BVY 13-003

SUBJECT: Response to Request for Additional Information Regarding Inservice Inspection  
Program Relief Request ISI-PT-02  
Vermont Yankee Nuclear Power Station  
Docket No. 50-271  
License No. DPR-28

Attachments: 1. Response to Request for Additional Information

Enclosures: 1. Reactor Pressure Vessel Head Flange Leak-Off Lines Piping and Instrumentation Diagram; Drawing 5920-00327 and Drawing 5920-02051

5920-327 R 5

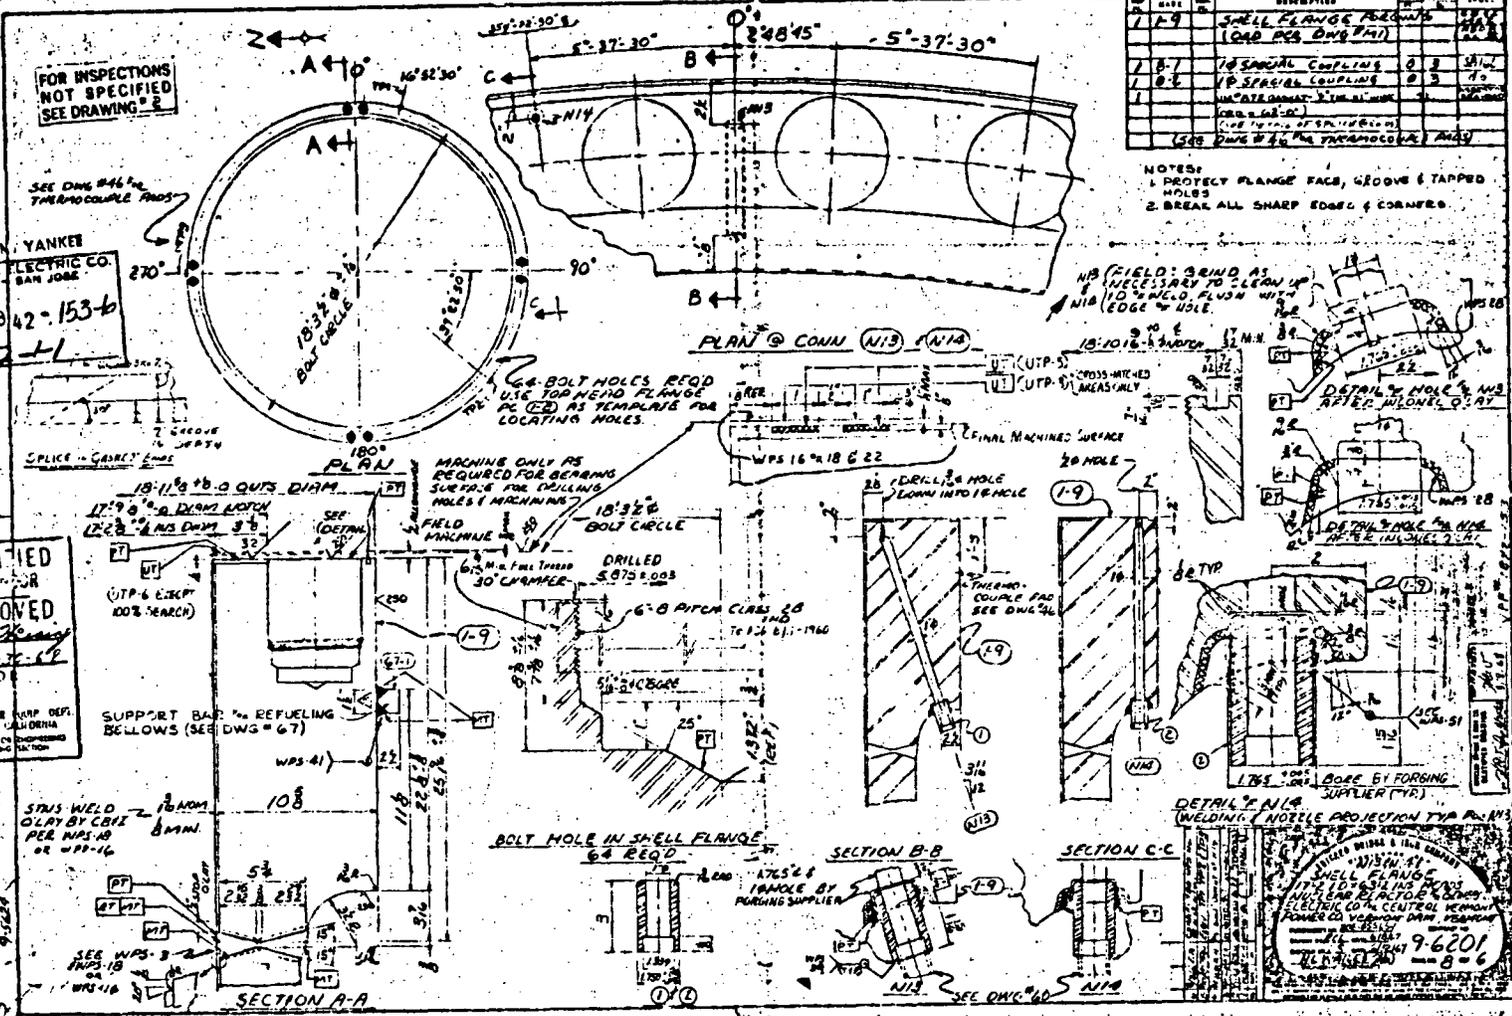
- 
- (b) Provide a detailed drawing of the configuration of the opening of N13 and N14 at the seal ring area and the connection between the N13 and N14 nozzles and the leakoff system piping, which shows how the connections are fastened to the reactor vessel flange.

- 
- 
- (c) Discuss whether the N13 and N14 taps are pipes inserted into the RPV head flange or a bore hole inside the head flange.

The configuration of the openings for N13 and N14 at the seal ring area is shown on drawing 5920-00327 provided in Enclosure 1. Section B-B shows the 3/16 inch diameter hole drilled between the seal rings for N13. Section C-C shows the 1/2 inch diameter hole drilled on the outside of the outer seal ring.

Details for the connection of the N13 and N14 nozzles to the system piping are also shown on drawing 5920-00327. There are two nozzle details below Section B-B and Section C-C and three more along the right side of the drawing.

For each of the taps, a bore hole is drilled through the RPV head lower flange. These bore holes are shown on drawing 5920-00327 in Sections B-B and C-C.
